SUBJECT: HUMBOLDT BAY POWER PLANT UNIT 3 - ISSUANCE OF AMENDMENT
REGARDING SPENT FUEL CASK HANDLING (TAC NO. L52634)

SAFETY EVALUATION BY OFFICE OF NUCLEAR MATERIAL SAFETY AND SAFEGUARDS
AND THE OFFICE OF NUCLEAR REACTOR REGULATION
RELATED TO AMENDMENT NO. 37 TO FACILITY OPERATING LICENSE NO. DPR-7
PACIFIC GAS AND ELECTRIC COMPANY
HUMBOLDT BAY POWER PLANT, UNIT 3
DOCKET NO. 50-133

Figure 1. Counterbalance valve schematic

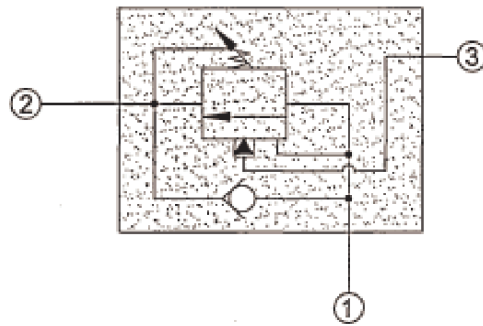
Describing the dynamic effects on the system from sudden movement, the licensee stated, in its response, dated June 3, 2005, that the counterbalance valves protect the davit crane against additional loads imparted by any hydraulic line failure or loss of hydraulic pressure. Figure 2 shows the counterbalance valves and identifies extend and retract hydraulic lines as Lines B and A. If Line B fails catastrophically during a load lift, the check valve in the extend-side counterbalance valve prevents the reverse flow from the extend side of the cylinder, thus locking the cylinder in place. If Line A fails during load lowering, the loss of pressure at Port 3 causes the extend-side counterbalance valve to close preventing the venting of hydraulic fluid from extend side of the cylinder, thus locking the cylinder in position. A lock-up of the cylinders causes the crane to make a normal stop and remain in safe condition without requiring any manual actions. All active lifting components are accessible and can be repaired or replaced with a load on the crane without risk of a load drop.

Figure 2. Double-acting counterbalance valve system for the davit crane

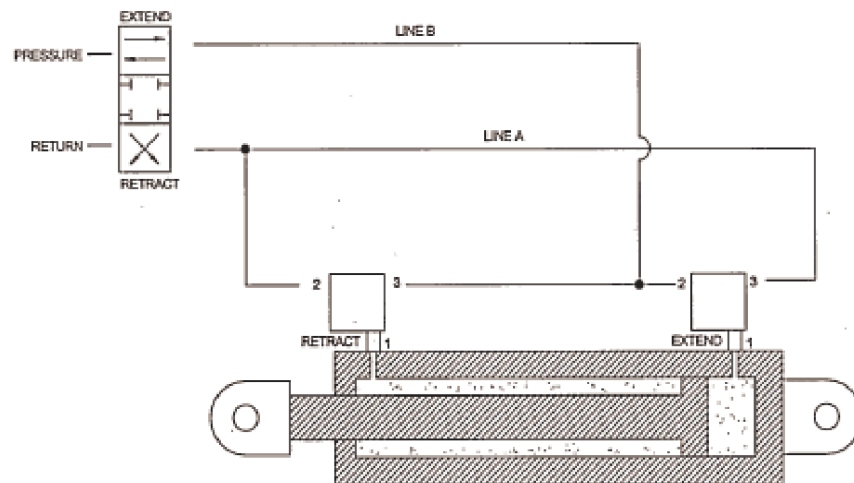
2004, RAI, the staff requested that the licensee describe: (1) the passive safety features of the hydraulics; (2) the dynamic effects on the system from sudden movement, e.g., loss of hydraulic power by a rupture of a hydraulic line; and, (3) how the licensee would monitor and control the effect of wear and the resulting drop in frictional load holding capacity during the life of the crane. In response, the licensee stated in a letter, dated June 3, 2005, that both positioning cylinders are equipped with counterbalance valves, which passively protect the hydraulic systems by requiring hydraulic pressure in the line to extend or retract the cylinders. Figure 1 shows a schematic of a typical counterbalance valves with three ports to control the fluid flow to the cylinder. Hydraulic fluid is free to flow from Port 2 to Port 1 of the counterbalance valve. The check valve prevents the reverse flow from Port 1 to Port 2 unless (1) Port 3 is pressurized or (2) pressure at Port 1 exceeds the relief valve setting. Fluid flowing from the pump to the extend side of the double-acting hydraulic cylinders, as shown in Figure 2, causes the cylinders to extend and lift the load. During lifting, the check valve of the counterbalance valve prevents fluid flow out of the extend side. To lower the load the cylinders are retracted by applying pressure to the retract side of the cylinder. The same pressure is applied at Port 3 of the extend side counterbalance valve, which opens the pilot operated relief valve, allowing fluid to flow from the extend side of the cylinder to the reservoir, and thus, allowing the cylinder to retract. The speed of travel of both the strand jack motion and the davit positioning cylinders is limited to 12 inches per minute by equipment sizing and is not adjustable by the equipment operator.

The failure of the return line, as shown in Figure 2, in any of the four cases does not result in any loss of control of the load, as the counterbalance valves will continue to control the travel at the designated speed by the orifice size in the counterbalance valves. Directly mounting the counterbalance valves to the cylinder eliminates the potential for a line failure at the cylinder hydraulic connection.

In all cases, the cylinder is protected against a catastrophic line failure. The three-way valve shown in Figure 2 prevents pump pressure from reaching the retract side and extend side simultaneously.

The staff accepts the licensee's response which shows that although the davit crane does not employ holding brakes (1) it has passive safety features of hydraulics to stop and hold the load; and (2) it is equipped with the counterbalance valves protecting it against additional loads imparted by any hydraulic line failure or loss of hydraulic pressure. In addition, wear of strands is not an issue, because they are used below the design capacity, the crane has a limited use, and the licensee will inspect the strands before each lift and replace them, if needed.
